FIS920030114US1  
David V. Horak, et al.

ANNOTED MARKED UP DRAWINGS

FIG. 3

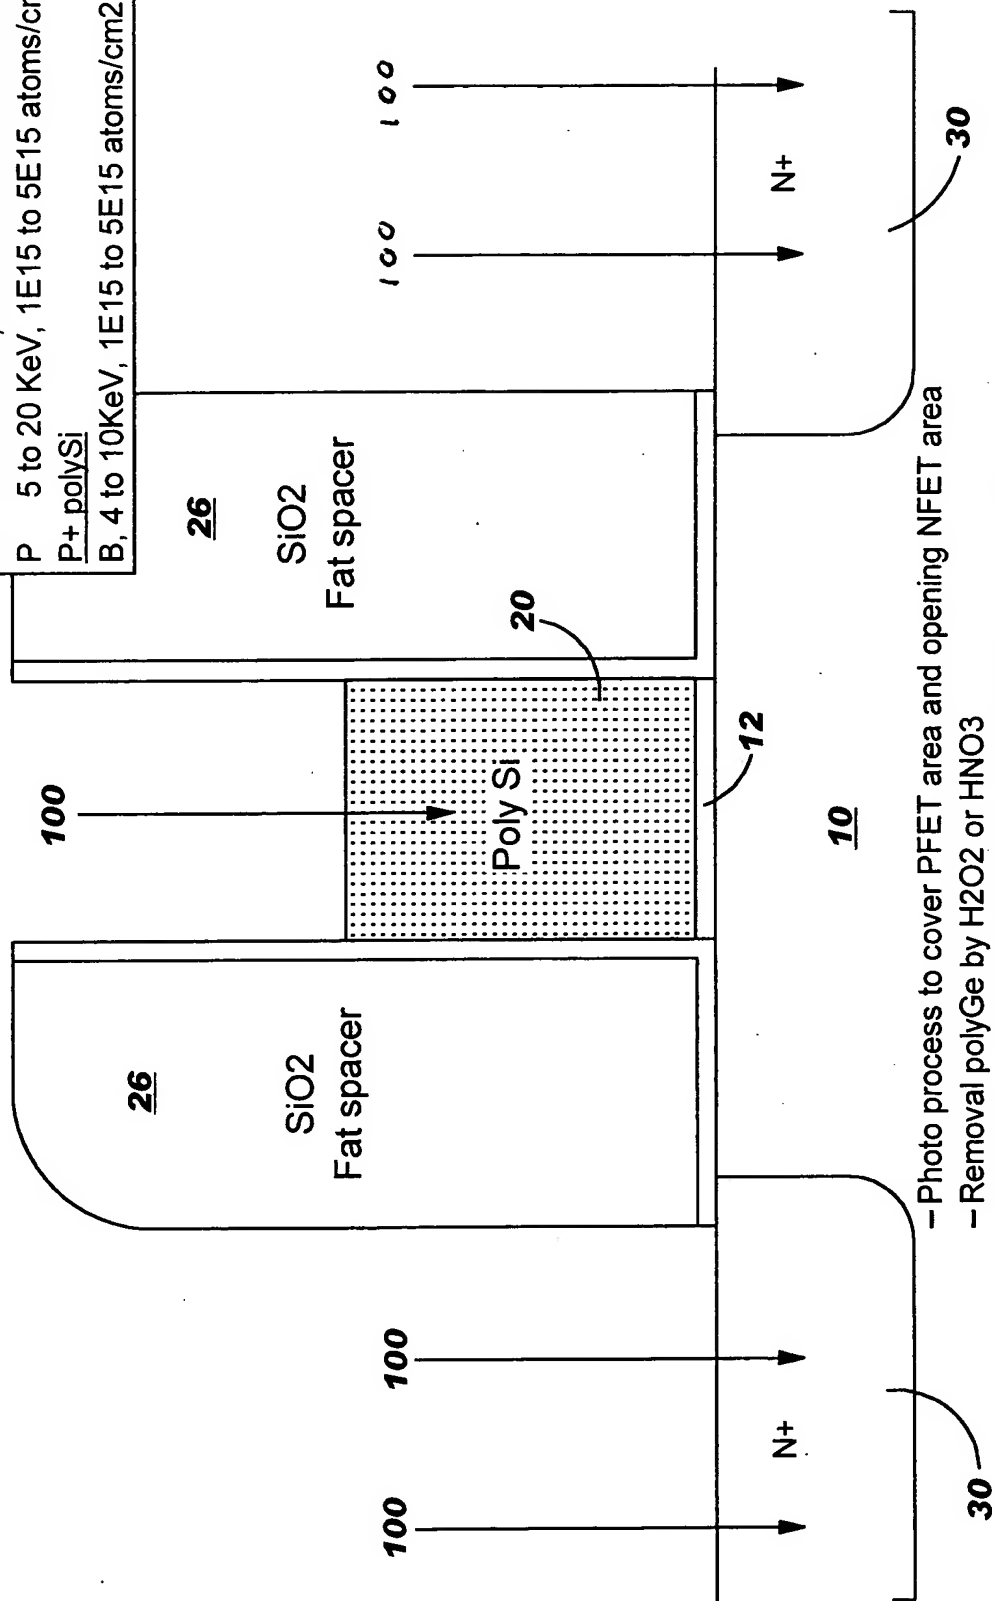
With respect to the drawings, the Examiner noted that the reference numbers “30” and “44” are shown in the figures, but not mentioned in the description, and that the two rightmost vertical arrows in Fig. 3 should be labeled “100.” The Examiner also observed that Figs. 4 and 5 both include a top center arrow that is not labeled or described in the specification, and that in Fig. 6, the “40” should be “42.”

More specifically, in the drawings, in Figure 3, the rightmost arrows are being labeled “100,” and in Figures 4 and 5, the top center arrows are being deleted. Further, in Figure 5, the reference number “44” has been removed, and in Figure 6, the reference number “42” has been changed to “44.” Also, the specification, in paragraph 24 is being amended to reference the extension regions 30 shown in Figures 3, 4 and 5.
